# SERVICE BULLETIN

ENGINE INDICATING — THERMOCOUPLE, EXHAUST GAS TEMPERATURE  
(EGT) — INTRODUCTION OF

V2500 Series 77-0011

V2500-ENG-77-0011

LOCATION OF FOUR EGT THERMOCOUPLES  
FIGURE 1

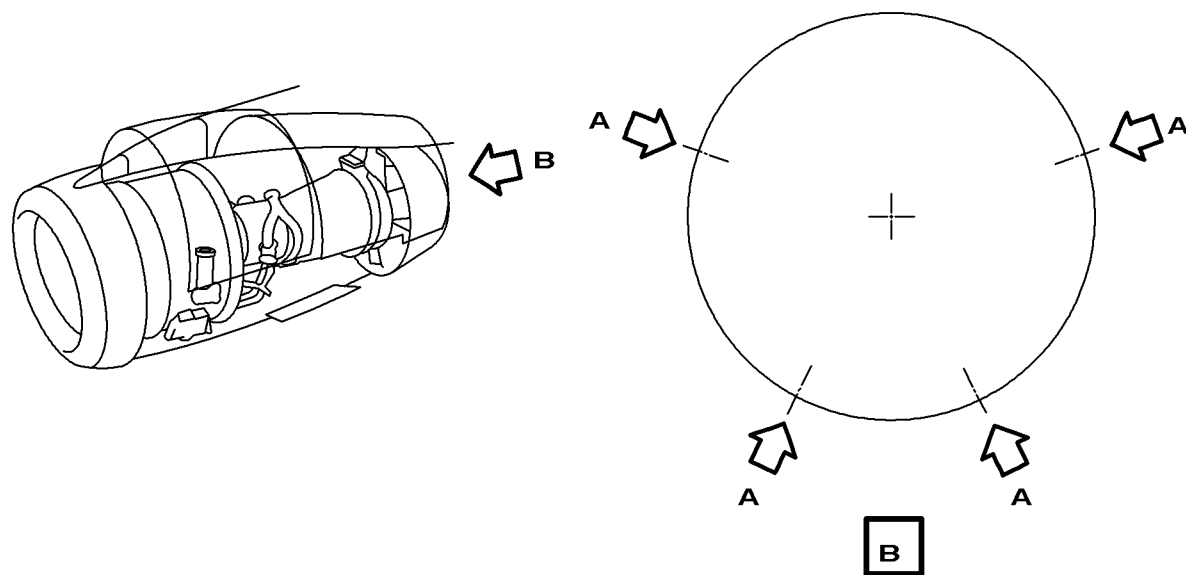
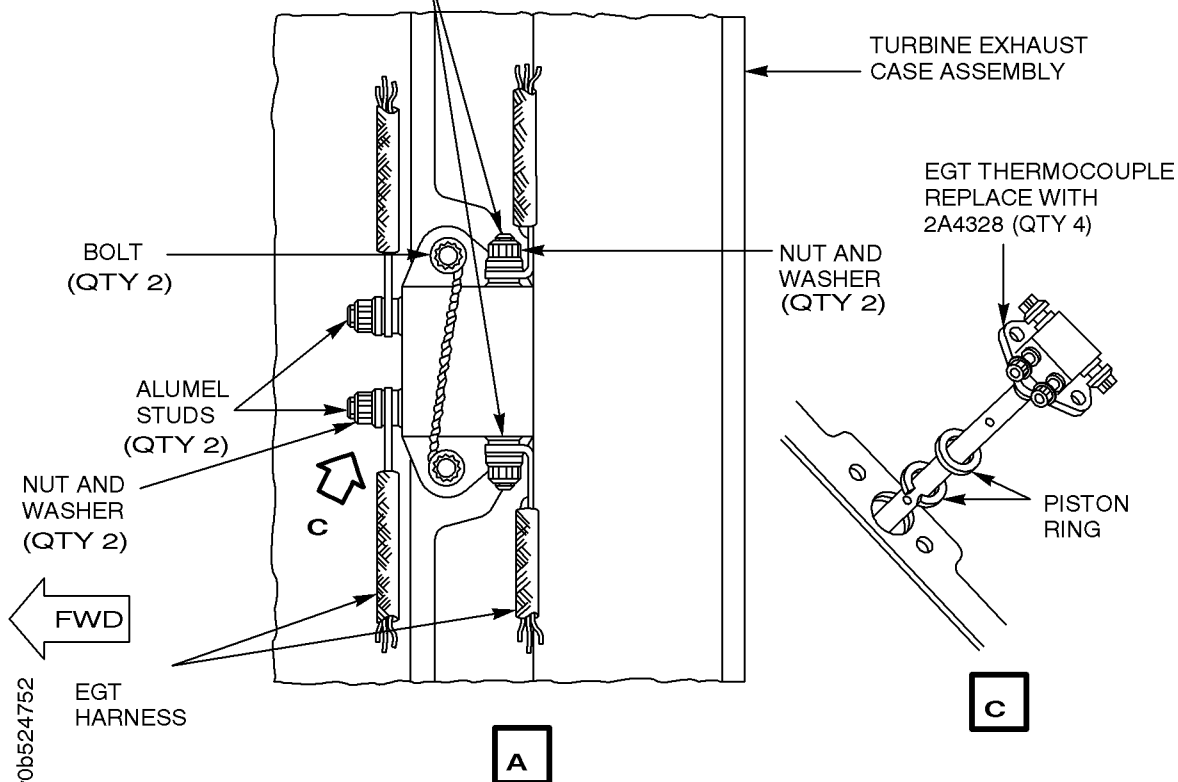
1. Open cowl doors and remove 4 old Exhaust Gas Temperature (EGT) Thermocouples from the Turbine Exhaust Case per Reference 3 AMM Task 77-21-15-000-010-A for V2500-A1/A5 Engines or Reference 4 AMM Task 77-21-02-020-801 for V2500-D5 Engines.
2. Install the 4 new EGT Thermocouples, PN 2A4328 into Turbine Exhaust Case per one of the following tasks:

- (1) While securing the thermocouple harness leads to the EGT thermocouple, torque the alumel connection nut (larger stud) to between 18 and 22 lbf in (2,034 – 2,486 Nm). See Figure 1 for alumel stud.
- (2) While securing the thermocouple harness leads to the EGT thermocouple, torque the chromel connection nut (smaller stud) to between 15 and 18 lbf in (1,695 – 2,034 Nm). See Figure 1 for chromel stud.

- (1) While securing the thermocouple harness leads to the EGT thermocouple, torque the alumel connection nut (larger stud) to between 18 and 22 lbf in (2,034 – 2,486 Nm). See Figure 1 for alumel stud.
- (2) While securing the thermocouple harness leads to the EGT thermocouple, torque the chromel connection nut (smaller stud) to between 15 and 18 lbf in (1,695 – 2,034 Nm). See Figure 1 for chromel stud.

- (1) While securing the thermocouple harness leads to the EGT thermocouple, torque the alumel connection nut (larger stud) to between 18 and 22 lbf-in (2,034 – 2,486 Nm). See Figure 1 for alumel stud.
- (2) While securing the thermocouple harness leads to the EGT thermocouple, torque the chromel connection nut (smaller stud) to between 15 and 18 lbf-in (1,695 – 2,034 Nm). See Figure 1 for chromel stud.
